Historic District Review Committee

Staff Report February 8, 2010

CAPP 2010-0002 Madison: New Residential Construction in the Waterford Historic District: MCPI 304-46-4671.

Photo 13: Example of proposed mortar at the Pink House addition at 40174 Main Street in Waterford.

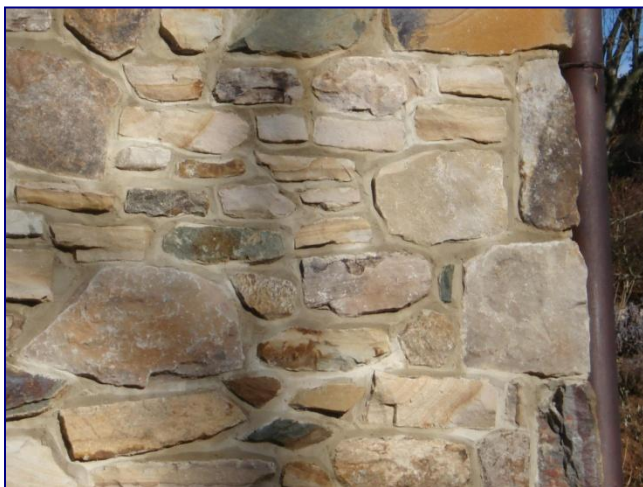
The applicant proposes mortar and a mortar joint that matches those found on the Pink House stone addition at 40174 Main Street (Photo 13). **The mortar and mortar joint employed on this addition are in keeping with the size, color, shape, and texture, as well as mortar width and tooling, of stone foundations in the Waterford Historic District and meets the Guidelines** (*Waterford Guidelines, Guidelines for Materials: Stone and Brick, Guidelines 2 and 7, p. 123*).
